CHANCEL WINDOW OF KETTERING CHURCH.

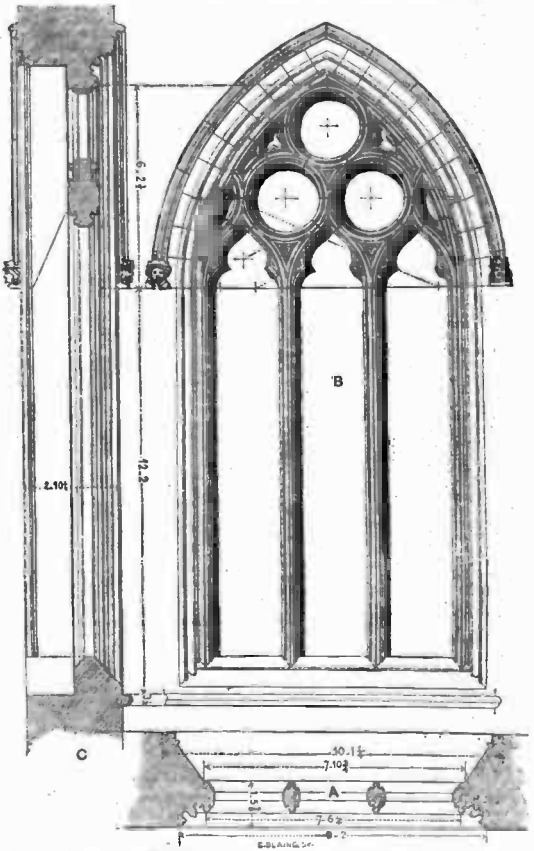
arch, wherever any peculiar development or construction of the work ought to be shewn. In the elevation are marked the centres from which the curvatures of the work are struck. Mr. Billings has also given us an enlarged section or plan of the external parts of the window-jamb; but we should have been bette

pleased if the same draught had contained also the inner mouldings of the jamb, including those peculiar ones at its arris: we should have liked the whole section of the mullion and the profiles of the different parts of the tracery-moulds, and also the section of the sill within and without the building, so that a workman might execute every part of the masonry correctly, without a doubt, and without a blunder.

The label, a section of which we here give, is designed without the elegance of spirit which dictated the rest of the invention: its abundance of small mouldings renders it illegible to the eye, while its general shape does not follow the beauty usually so perspicuous in the profiles of examples of Pointed Architecture. We give it here rather for avoidance than imitation. When the spirit of Pointed Architecture reanimates the science in modern times masonically and corporeally, mere timid imitation will be exploded, the errors of former works will be corrected with the same anxiety as it is not only fair to suppose, but evident and patent, the freemasons ever strove to act in the olden times, constantly aiming (while architecture was ordained to advance towards its zenith) to improve upon former endeavours.

We now proceed to say wherein our present delineations of the Kettering window fall short of our ideas of just requirement. We deem them imperfect, from not shewing exactly the jointing of the masonry of the jambs mullions and sill; we should wish the insertion of the saddle-bars and stanchions, and the pattern of the glazing: and, further, if there be any remaining of tracery, or work, we should

desire to have them distinctly shewn, in order that judgment may be formed of the causes of such failure, and thence philosophical deductions be made for their avoidance in a shrewd modern reproduction of the work. To these we desire to have added the date of the subject as far as can be authenticated, as well by documents as by the taste of its design; also the nature of the materials used in the work, how they have been affected by time, and whether they have been repaired by cements or otherwise, or if they have been renewed; whether the superincumbent weight has not been, by the great head-arch, duly discharged from the tracery and mullions. We desire to have an account of what derangement and fractures have occurred in the mullions and tracery; also what effect has been produced on the masonry by the iron-work fixed therein.

The mode of inserting the dimensions upon the drawings we find imperfect, inasmuch as their values are not given by setting over them "*Feet, Inches*" or "*ft. ins.*," or the marks ° and ′; they do not, therefore, convey definitely their meaning, which has to be only implied from the supposition that they cannot mean any thing else than the true one. This is not sufficient; they should be so plainly indicated that a youth, an amateur, or any foreigner not well acquainted with the customary measures of English workmen, may acquire their meaning without any extraneous questioning. We here add a scale which we have made for the general elevation plan and section of the window, which was deficient in the drawings; and we at the same time beg to say this exhibits the mode in which we wish scales to be made, written to, and figured.
